SCHEMATIC REVIEW - APPROVED

RE: QUIZNOS SUB
Magazine Street
28701 Magazine Street Suite 4
New Orleans, LA 70113
(Accepted 11-22-05)

Enclosed: layout for Store #9880

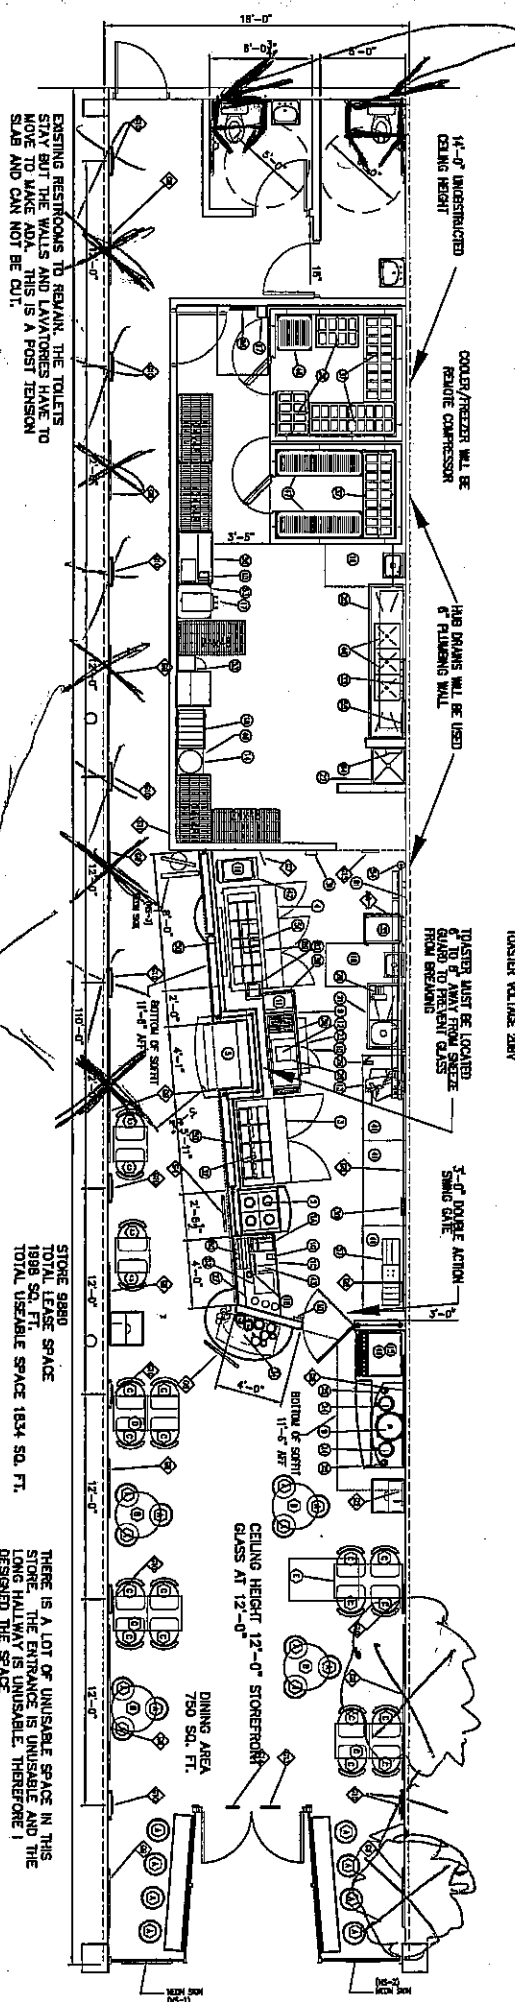
- a. Only four G9 posters are in the art package, with one toasty poster. Revise per the attached.
- b. Restroom cabinets are required. Revise per the attached.
- c. Remove Pilasters in back, only 4 Required.

*RCS room
cabinets
are required*

14 total 15 posters
